### CAPE DAM-BREACH & CHANNEL RESTORATION

**Figure 1a. Project Area Map (above) as depicted in US Fish & Wildlife Service (USFWS) report dated April 2016.**

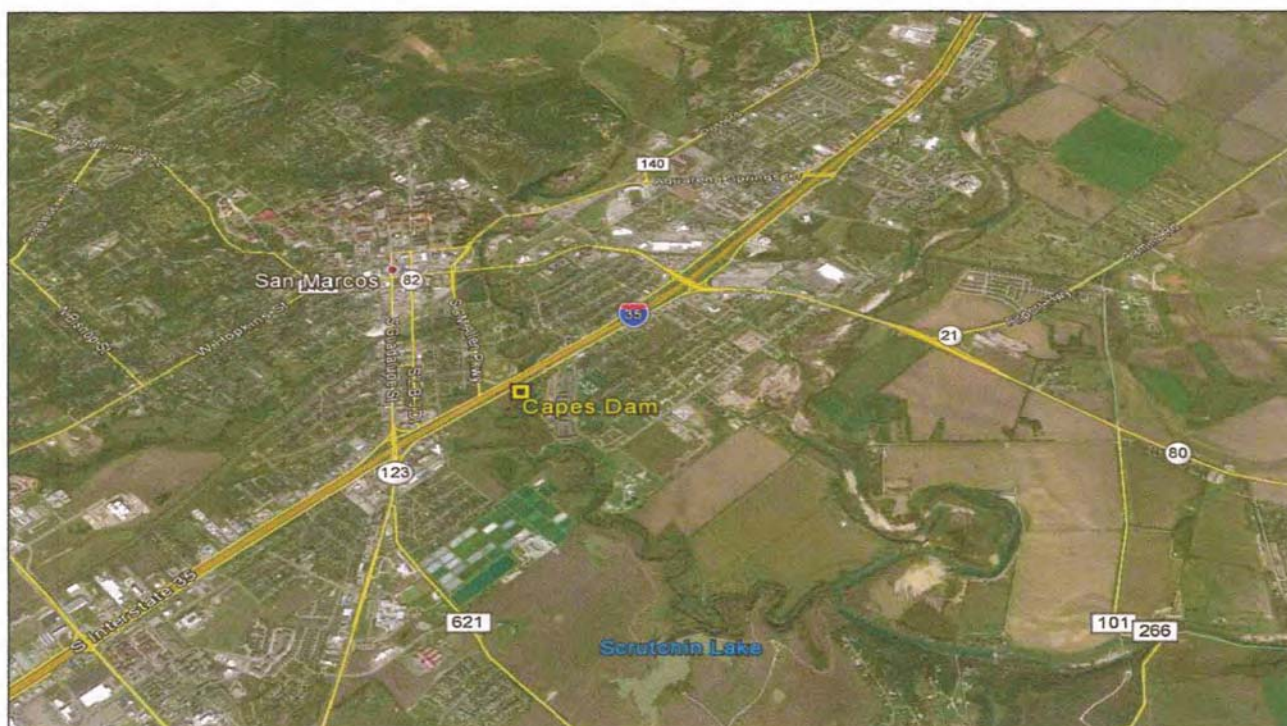
This project aerial photograph is deficient because 1) Mis-identifies the location of Capes Dam, the subject of the report, as being directly next to I-35; 2) is taken at such a high elevation that it doesn't show any detail; and 3) is mis-appropriately named “Capes Dam-Breach & Channel Restoration.” This report is about *removing* Capes Dam, not channel restoration. The channel will be highly-disturbed, and not restored, for many years after, if Capes Dam is removed.

SAN MARCOS, TEXAS		EXISTING SITE ALIGNMENT &		SUB-SHEET	
CAPES DAM-BREACH & CHANNEL RESTORATION		SECTION LINE SAMPLING LOCATIONS		2	
DESIGNED	DRAWN	CHECKED	DATE	DRAWING NO.	SHEET
W. STANCILL	W. STANCILL	W. RICE	4/2018	8R-TX-2018-002	2 OF 7

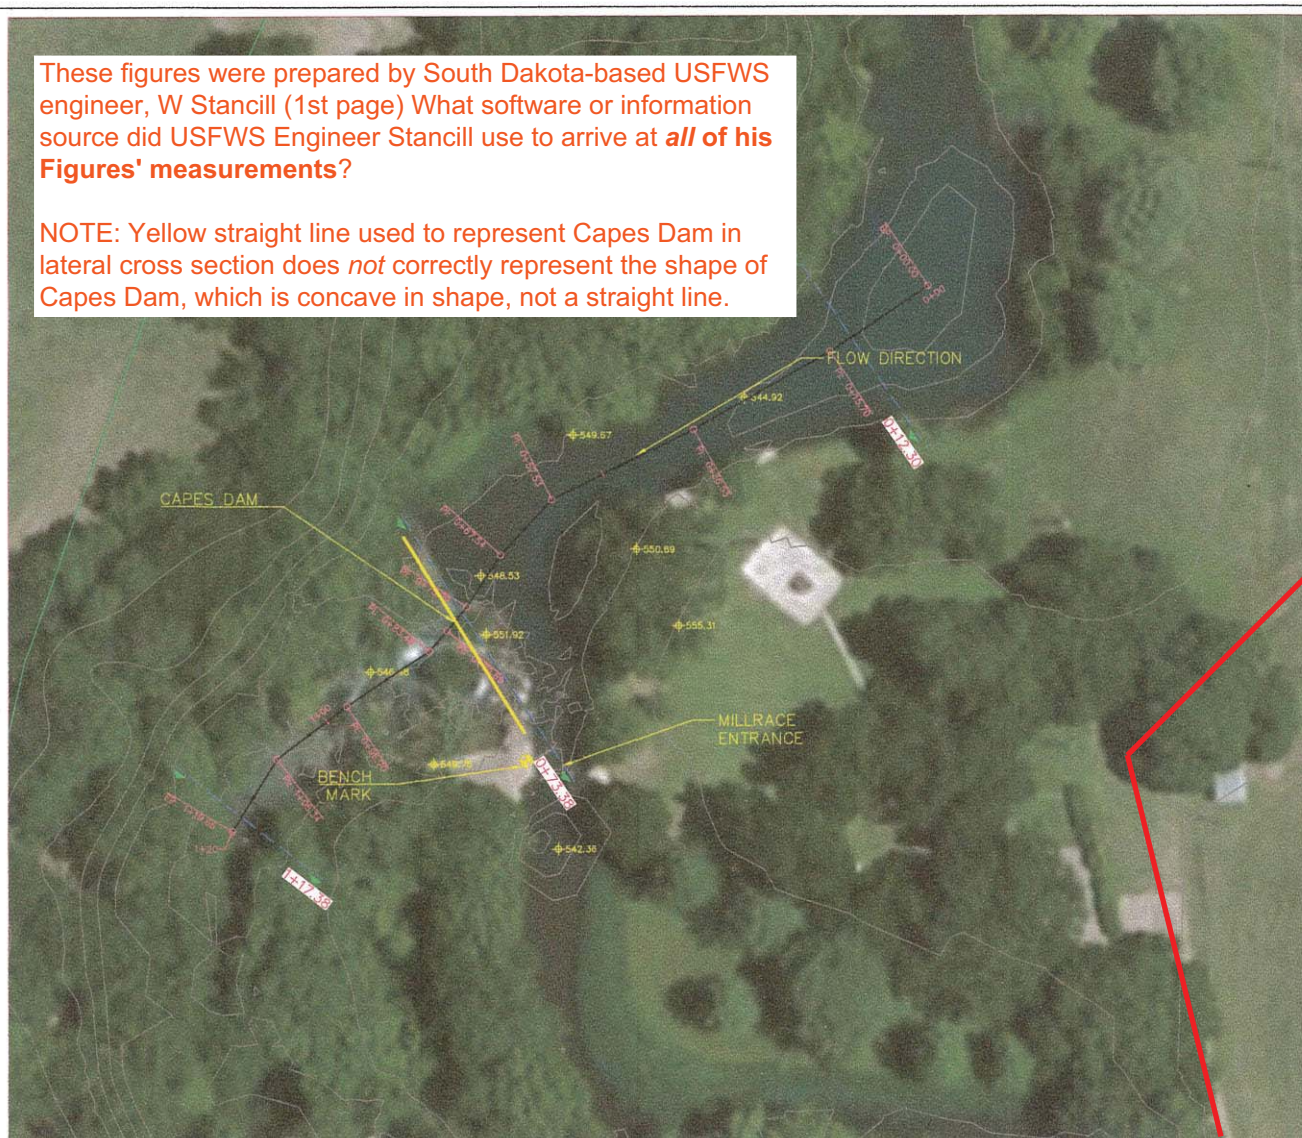
NOTE: Yellow straight line used to represent Capes Dam in lateral cross section does *not* correctly represent the shape of Capes Dam, which is concave in shape, not a straight line.

Use of outdated photograph; This area now occupied by 24-acre apartment complex with an estimated 80-90% impervious cover, all of which drains its rainwater run-off directly into the San Marcos River (2 drains) or the Mill Race (3 drains.)

CAPE DAM, ~ 600 CFS, VIEW ACROSS DAM FROM MILLRACE INLET  
These photos are dated April 2016 (see legend below); there was no recorded 600 cfs flow in April 2016.

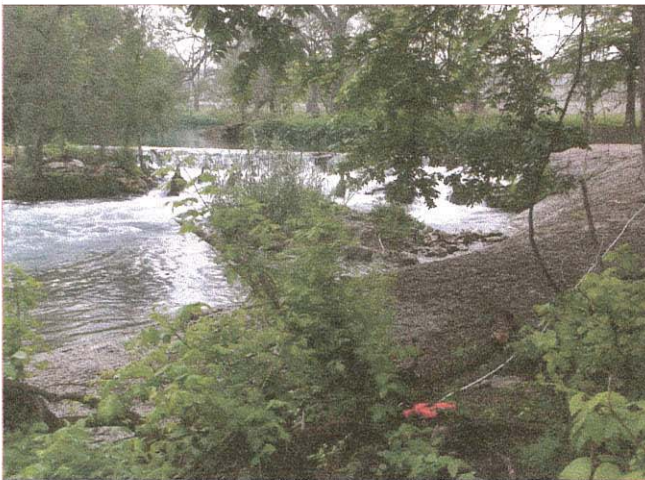
MILLRACE INLET, VIEW DOWNSTREAM TO UPSTREAM  
The pediments of what once was the Mill Race headgate only begin to be visible when water discharge falls below approx. 280 cfs.

CAPE DAM, ~ 600 CFS, VIEW DOWNSTREAM TO UPSTREAM

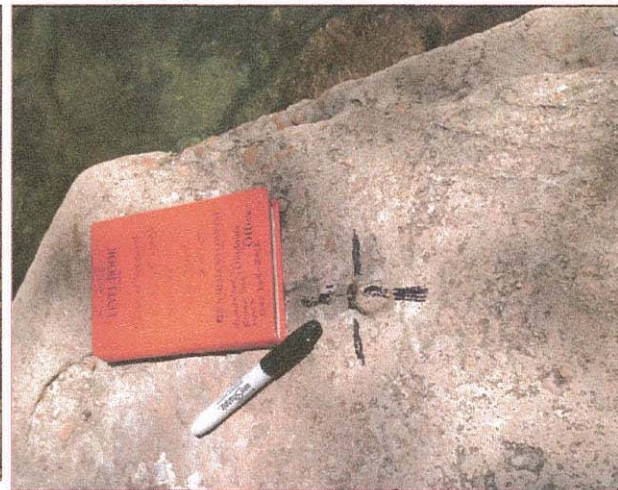
If this were 600 cfs, the water would be much higher, covering the concrete apron on the north side of Thompson's Island. See pages 7-9 of this report for documented photos of 266 CFS, 630 CFS, and 400 CFS.

## Existing & Proposed Alignment Profile Details commentary

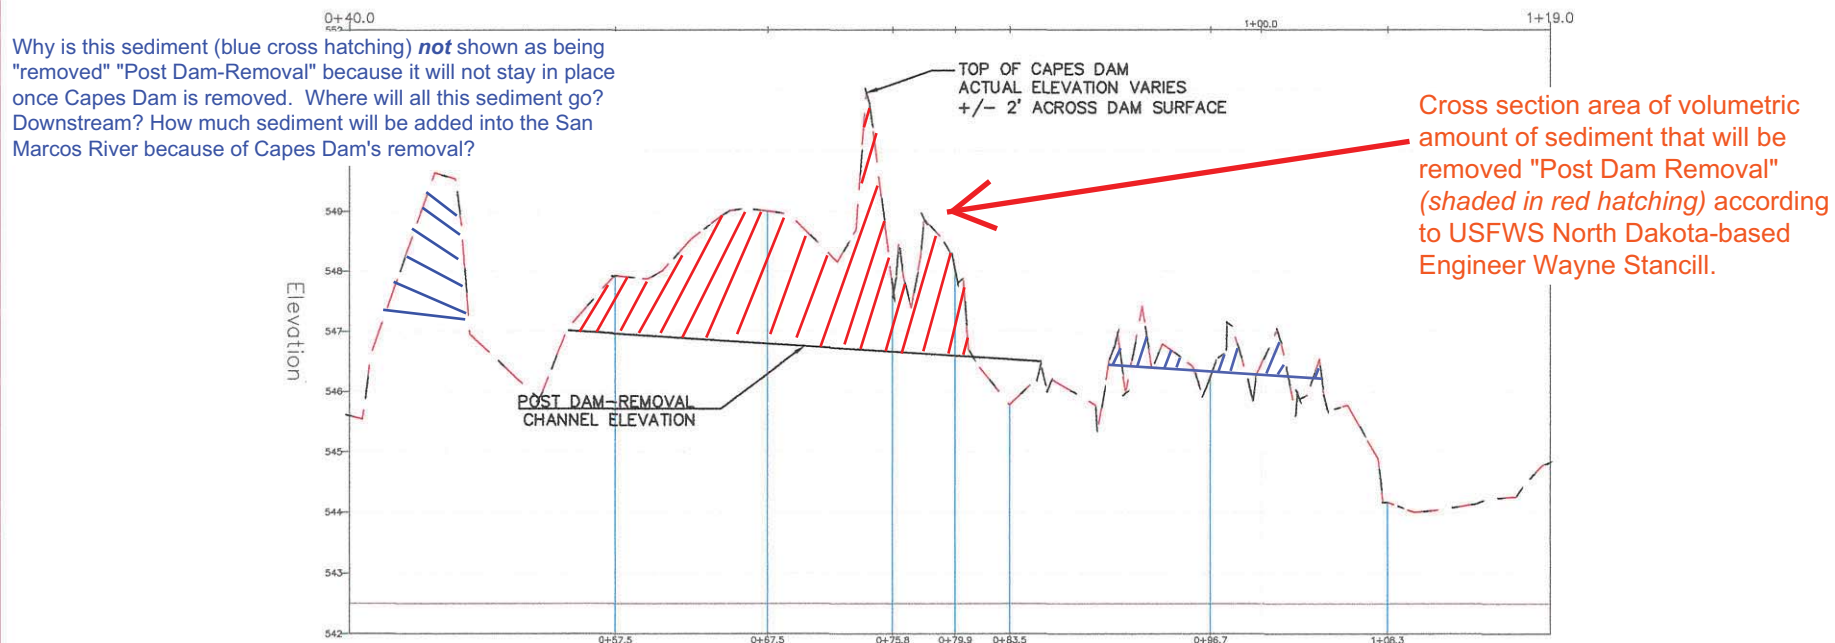
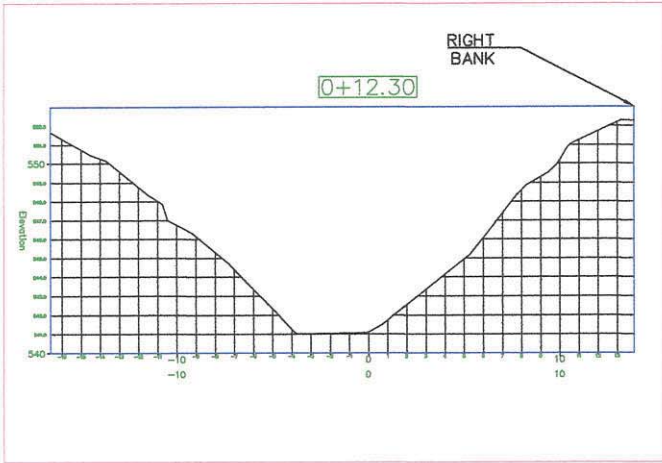
Because this Engineer's Drawing lacks a **Horizontal Scale**, no measurements can be made of the amount of sediment that will either 1) be removed and should be included in both TCEQ Info Sheet for Dam Removal and TPWD Sand and Gravel permits; **OR** 2) be removed by the river over time, and be sent downstream, greatly increasing sedimentation rates downstream from what once was Capes Dam.

**This 3D volume of sediment taken away "Post Dam-Removal" must be able to be measured, quantified, and correctly described before any action to remove Capes Dam can occur.**

1) Will the "Post Dam-removal Channel Elevation" created by removal of the sediment that currently exists in the area shaded in red hatching **be accomplished by man-made removal?**

2) Will the "Post Dam-removal Channel Elevation" created by removal of the sediment that currently exists in the area shaded in red hatching **be accomplished by the river, over time?**

# Existing Site Section Line Details commentary

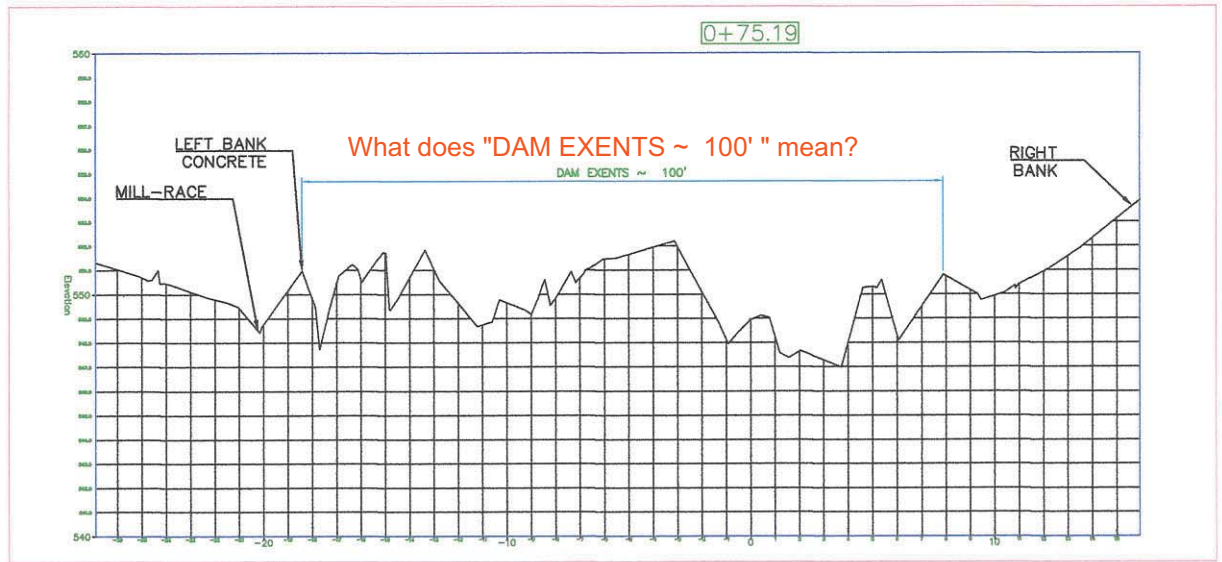
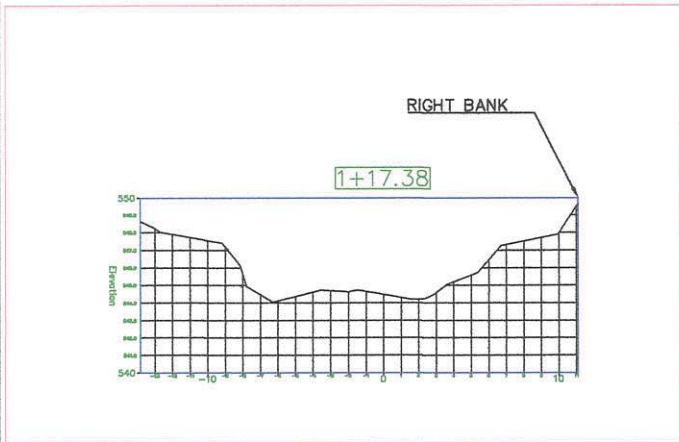
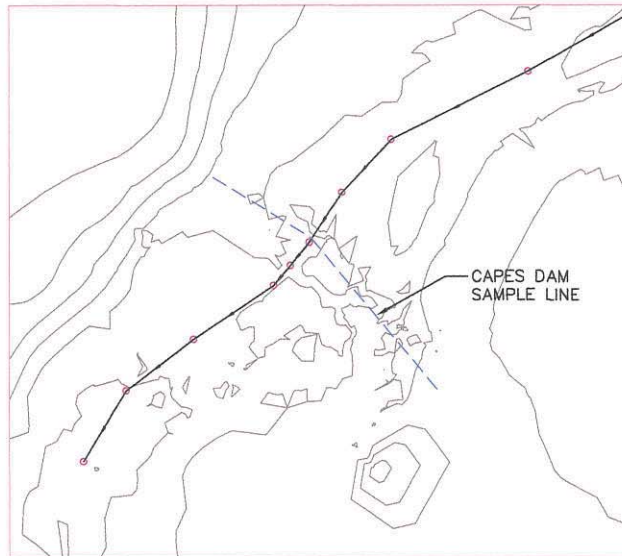
None of these drawings have a horizontal scale so measurements of the areas (2D) and volumes (3D) are not possible. Is this typical of the quality of work done by engineers employed or contracted to USFWS? The entire point of engineers' drawings are to have a certified measurements of physical structures. But when an organization assigns work to an engineer located over 1,000 miles away from the subject of his drawings, accuracy and useful data can be lacking.

# Proposed Site, Section Line Details at Dam commentary

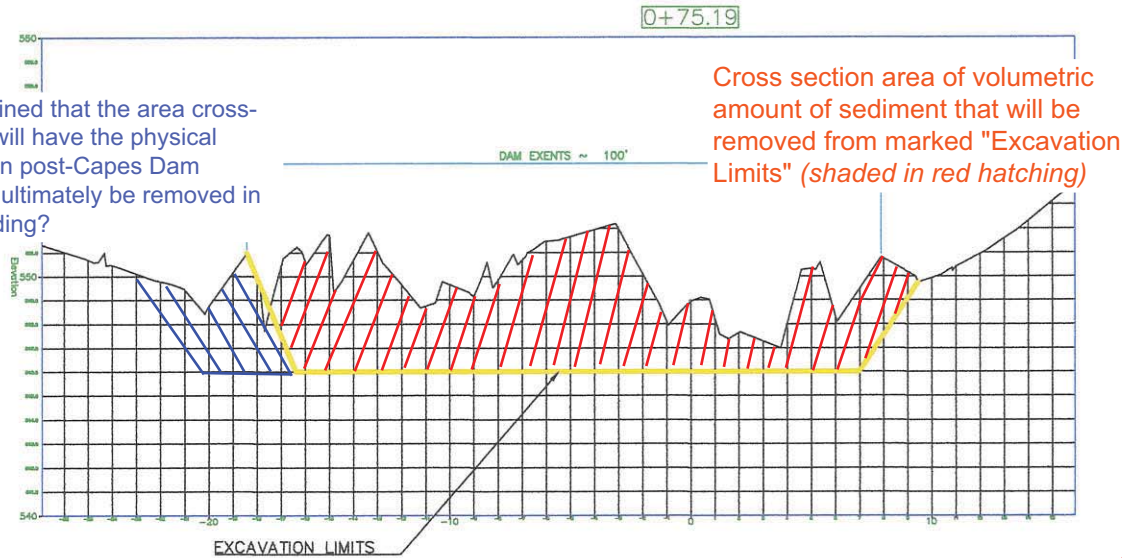
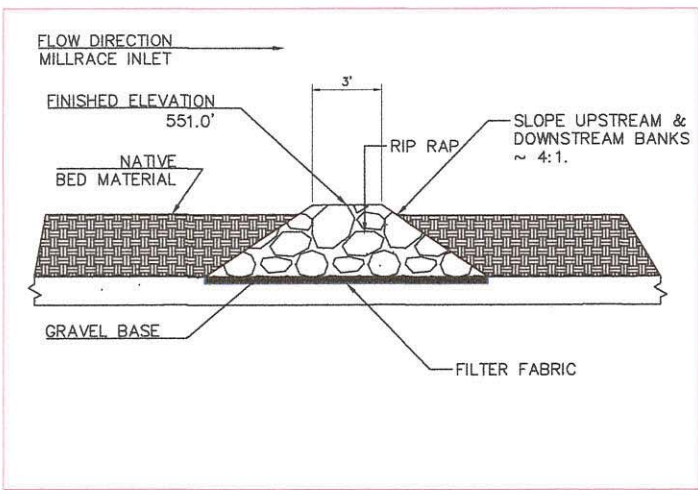
Has any geological work been done to investigate what rock Capes Dam is built upon? It appears that Capes Dam utilizes the upthrown side of a horst fault-block, part of the much larger Balcones Fault Zone. What will happen if this proposed Excavation of Capes Dam encounters an upthrown fault block that Capes Dam has merely utilized and enhanced?

Who has determined that the area cross-hatched in blue will have the physical integrity to remain post-Capes Dam removal and not ultimately be removed in subsequent flooding?

Cross section area of volumetric amount of sediment that will be removed from marked "Excavation Limits" (shaded in red hatching)

**Question:** What is being planned for the rainwater run-off drainage sewer pipes that drain the adjacent 24-acre apartment complex (which was omitted from these plans) of all rain-water? Three of these 5 drains empty into the Millrace. What will happen after the Millrace no longer receives fresh flows of water, and instead becomes a stagnant, Zika-mosquito-filled swamp? When it rains, and the 3 rainwater runoff sewage pipes dump their polluted water directly into the area formerly occupied by the Millrace, have any flood-studies been completed to show the effect on the now-dammed Millrace?

"4. **Excavated material deposited into the Millrace will be no larger than 8 cubic ft**" **Question:** Will individual boulders be no larger than 8 cubic ft (which can be approximated by a 2 foot-square cube)? What if individual boulders are larger than 8 cubic feet? Where will these larger boulders be deposited?

"5. **Rebar will not be removed from excavated material deposited in the Mill race.**" **Question:** Will concrete be removed from excavated material? Or will all materials, whether natural or man-made iron & concrete, be desposited into the natural-bank Millrace?

MILL RACE GRADE CONTROL				
CAPES DAM-BREACH CHANNEL RESTORATION & EROSION CONTROL DETAILS				
DESIGNED W. STANCLIFF	DRAWN W. STANCLIFF	CHECKED W. RICE	DATE 4/2016	DRAWING NO. GR-TX-2016-002
				SHEET 7 OF 7

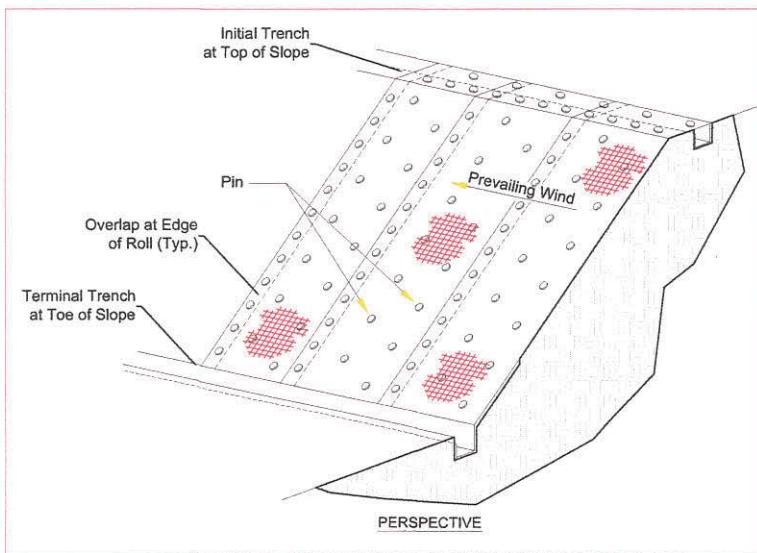
**WHY** does the Millrace HAVE to be damned-up and filled in?

**WHY** can't the San Marcos River and Millrace employ the **SAME Split-Flow regime** that Dr Thom Hardy (upon whose research Mike Montagne of USFWS has based his recommendations upon) is implementing in the hydrologic equivalent Comal River? (See [http://eahcp.org/index.php/habitat\\_protection/comal\\_springs/flow\\_split\\_management](http://eahcp.org/index.php/habitat_protection/comal_springs/flow_split_management) for discussion of Hardy-recommended Split-Flow of Comal River to create slow-moving Fountain Darter habitat.)

In the Comal River, Dr Hardy is recommending **the exact opposite of what is proposed for the San Marcos River**. In the Comal River a **Split-Flow regime is being created** between the Comal and the Old Channel **to provide better habitat in a larger area for the endangered Fountain Darter which prefer the slower-moving waters of the Old Channel**.

**WHY** can't our existing **Split-Flow regime** between the San Marcos River and the Millrace be maintained?
